**ESG-D Series Signal Generators
Option UN3/4 PHS Modification Kit
Kit Part Number E4400-60147**

Part Number E4400-90162

Option UN3/4 PHS Modulation Kit

The Option UN3/4 modification kit corrects the PHS base station frame triggering which was causing bit error rate faults. The kit contains a replacement U203 for the A8 data generator board and provides a firmware upgrade to the latest firmware revision.

Figure 3 U203 Location

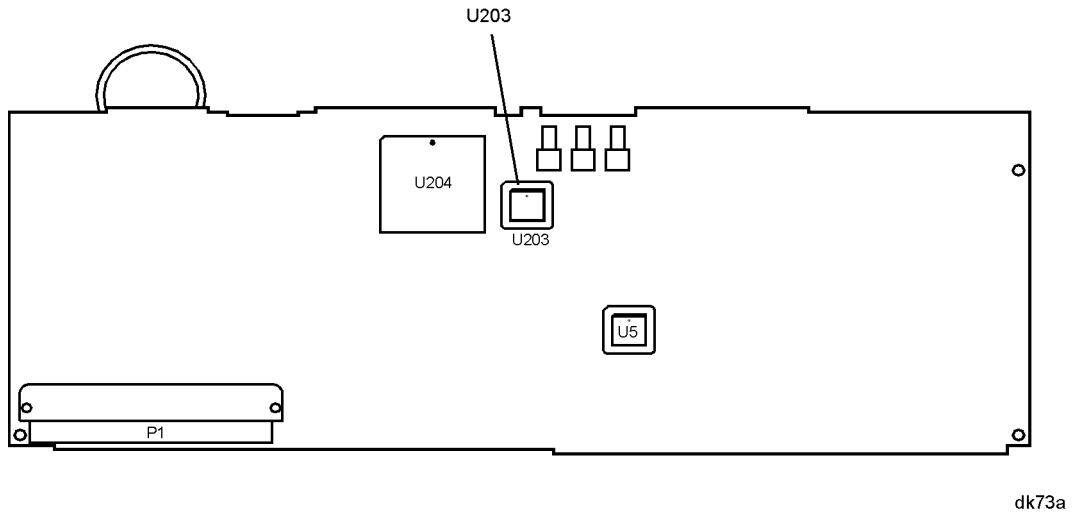
3. Install the new U203 on the A8 data generator board. (Refer to Figure 3.)
 - a. Locate U203 on the A8 data generator board.
 - b. Following the instruction sheet for the extraction tool, carefully remove the socketed EPROM U203 from the A8 data generator board.
 - c. Correctly position the new EPROM, U203, supplied in this kit, onto the socket of the A8 data generator board.
 - d. Carefully install the new EPROM, U203, using firm, direct pressure.
